BLOCK B - Elevation C Reference Elevation

Scope of works:

GLAZING ALTERATION TYPE 27

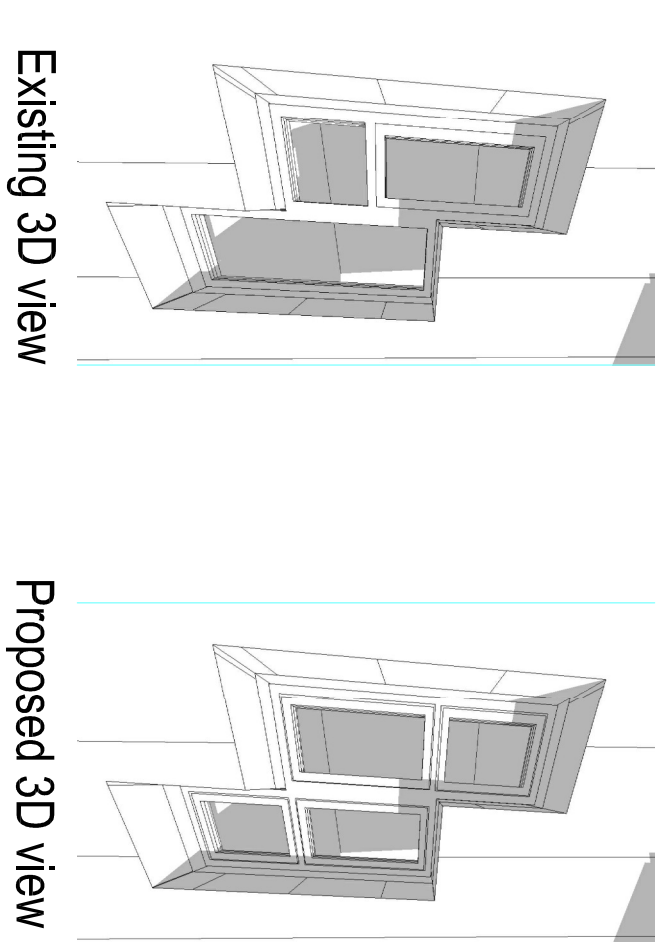
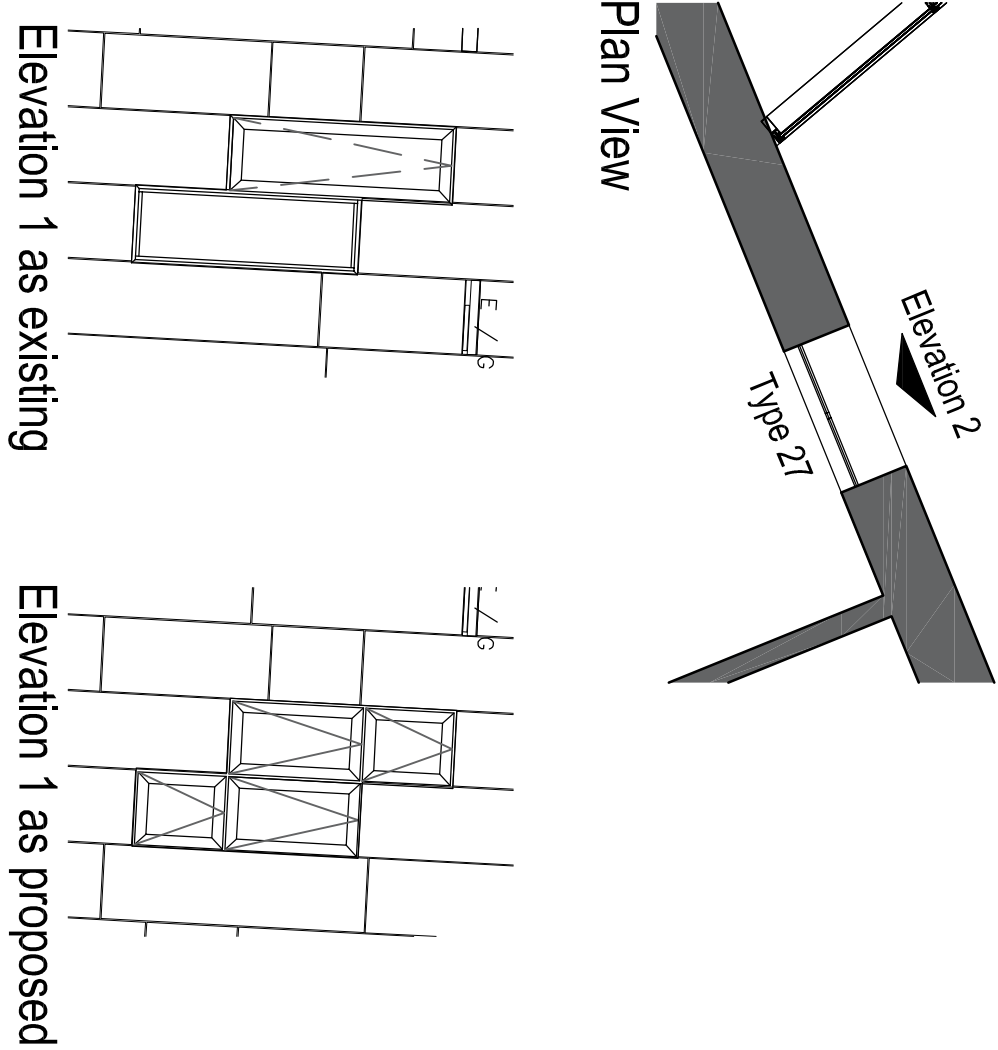
Type 27 window modification (11No.) - Replace existing windows with new 2 x 2no. stacked opening lights.

Type 27 window modification (2No.) - Replace existing windows with new 2 x 2no. stacked opening lights.

GLAZING ALTERATION TYPE G

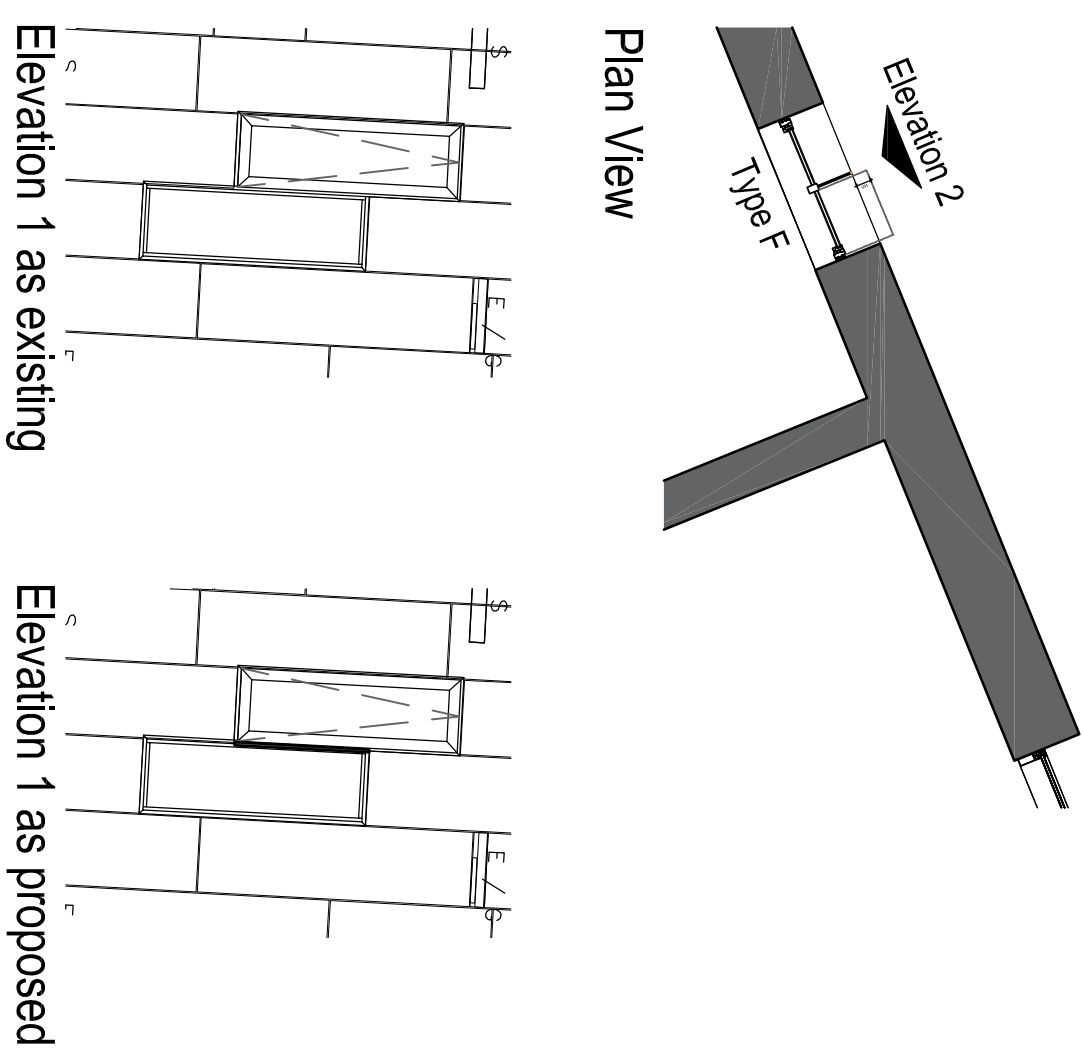
Type G (31No.) - Additional vertical guarding to be fixed externally to allow opening windows to open 100mm beyond outside face of cladding/brick.

Type G (31No.) - Additional vertical guarding to be fixed externally to allow opening windows to open 100mm beyond outside face of cladding/brick. Guarding to ensure there is no gap larger than 100mm to sides of opening windows. Detail in abeyance TBC
